Service Bulletin

Model : **GP160** **GP160DF** **No.:** GP160-007
GP160F **GP160PF** (FF-T01-E40-000050-01)
DATE: 10.08.99

Subject : **Parts Addition**

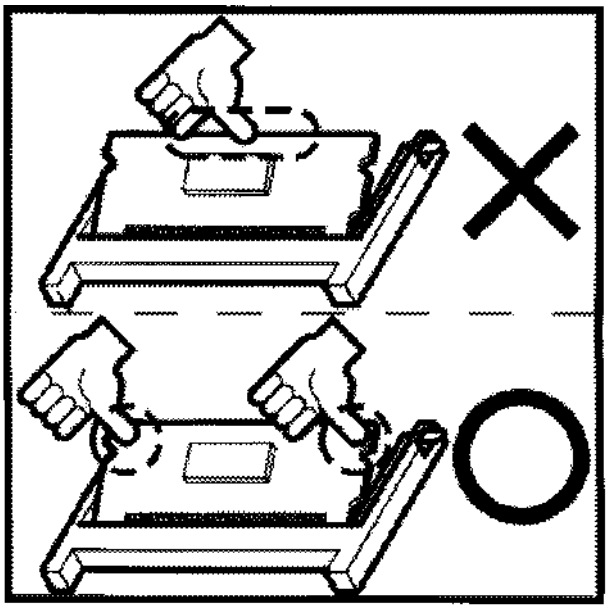
If the dead centre of the DIMM is pressed down forcefully,the pins of the IC chip could lift up.

Seals will be attached at the two points described below,warning not to press down on the middle of the DIMM,but at both ends.

1. Accessory DIMM
2. Service parts FLASH ROM ASSEMBLY
